SUNSET VILLAGE FILING NO. 4

CONSTRUCTION PLANS

SUNSET VILLAGE - FILING NO. 4

DEVELOPED DRAINAGE & EROSION CONTROL PLAN

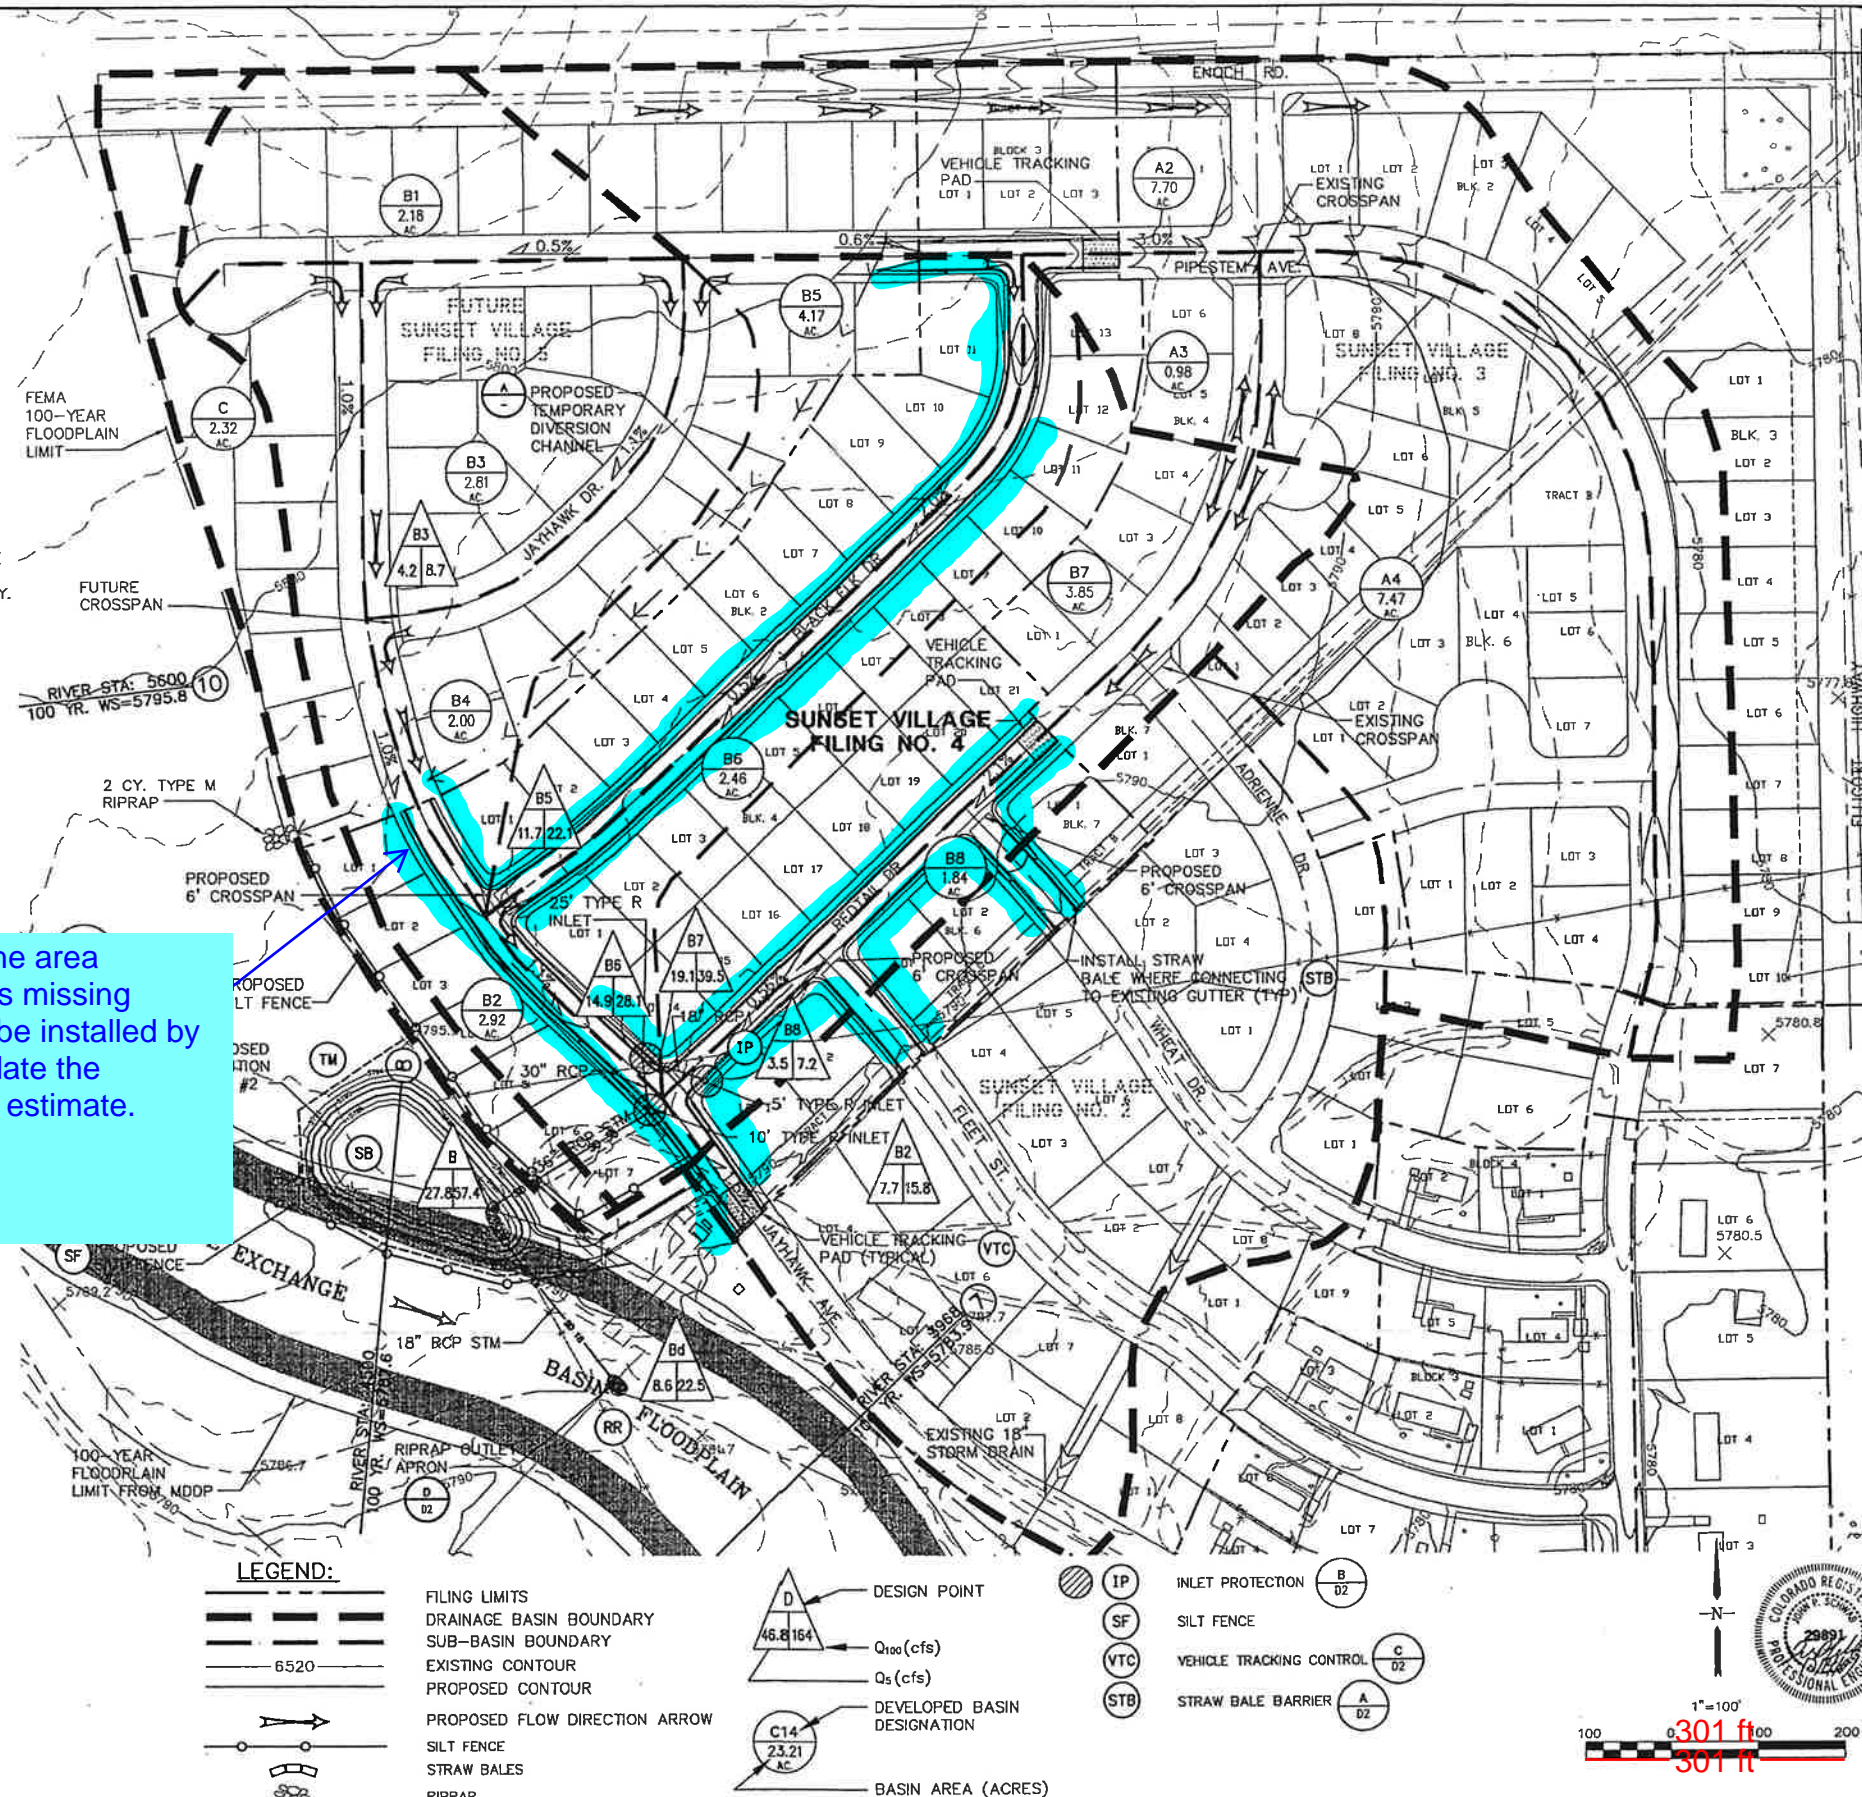
From aerial maps the area highlighted in blue is missing sidewalk that must be installed by the developer. Update the financial assurance estimate.
